EC70139 REV. 0
ATTACHMENT Z121R0
DWG. NO. 522-041-023

NO.	DESCRIPTION	DRAWN
REVISIONS		
NUCLEAR ENGINEERING		
CRYSTAL RIVER UNIT 3		
AUXILIARY BUILDING - SOUTH STEEL FRAMING MODIFICATIONS DETAILS		
EWN DRAWN	MPB CHKD.	X APRVD.
12/9/10 DATE		NQNE SCALE
023 SHEET	522-041	
DISC.	DWG.	REV.

DETAIL B
SCALE: 1/2"=1'-0"

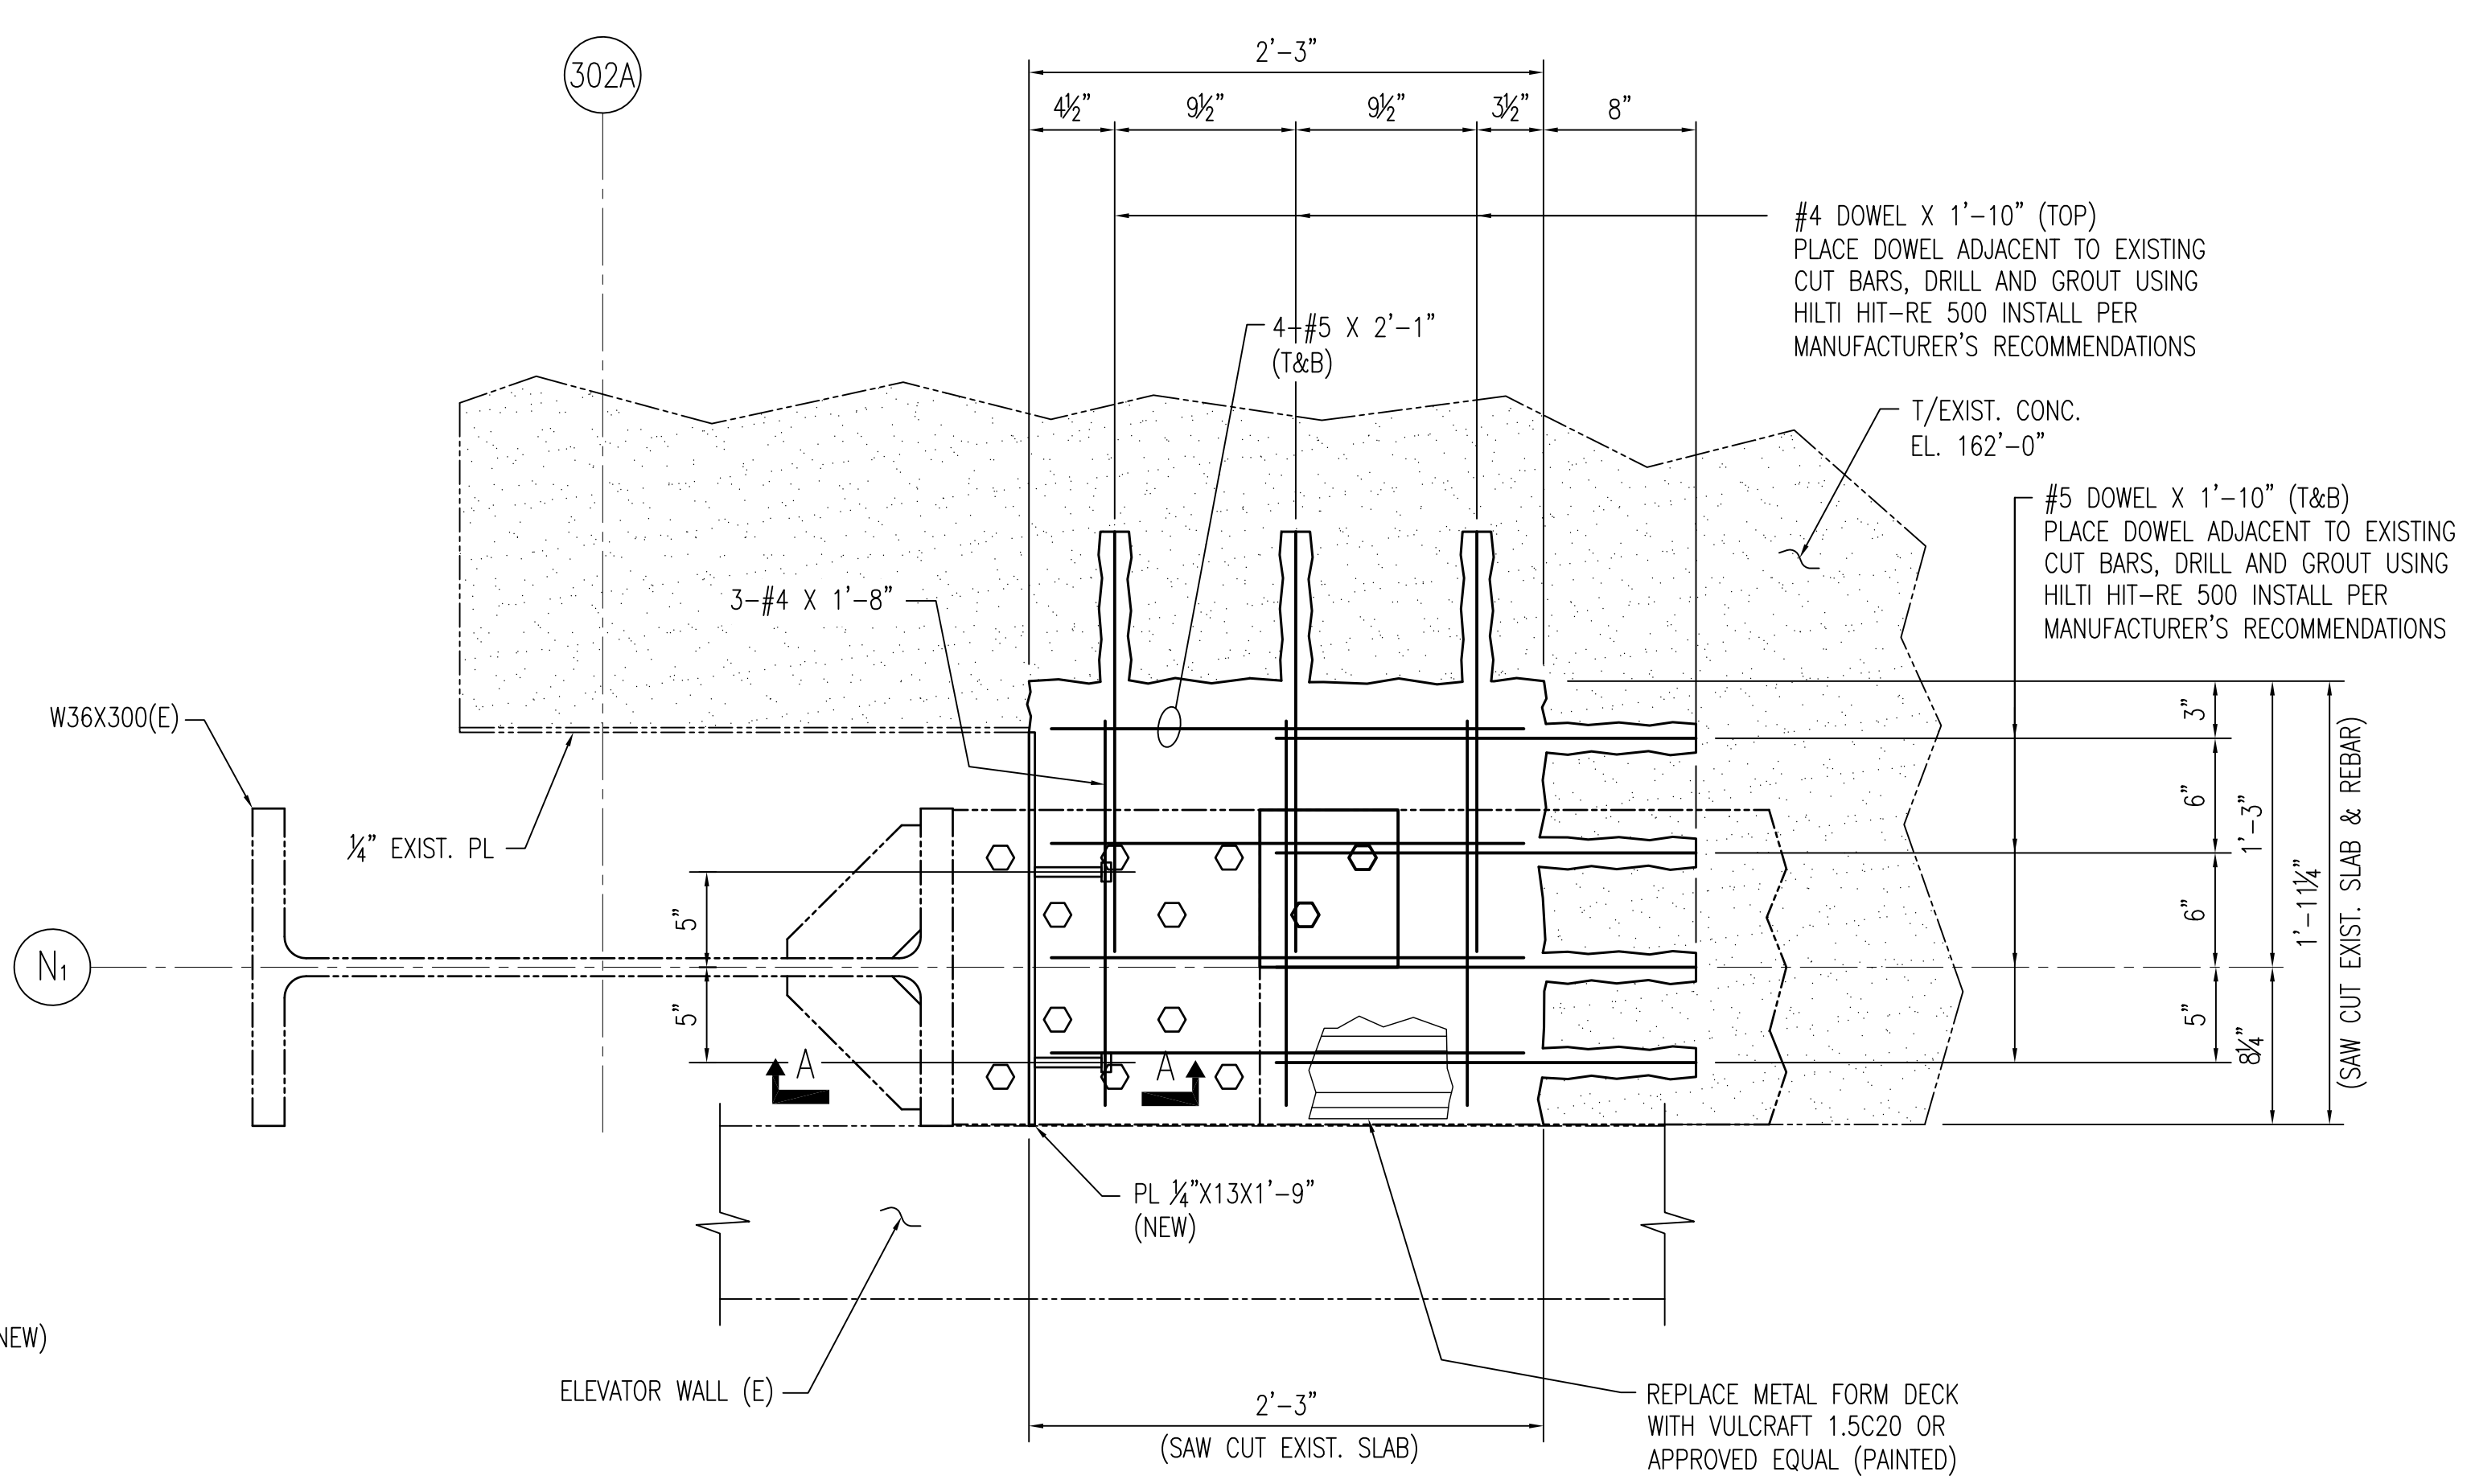
NOTE:
REPLACE CONCRETE SLAB WITH
4000PSI CONCRETE. FINISH TO
MATCH EXISTING.
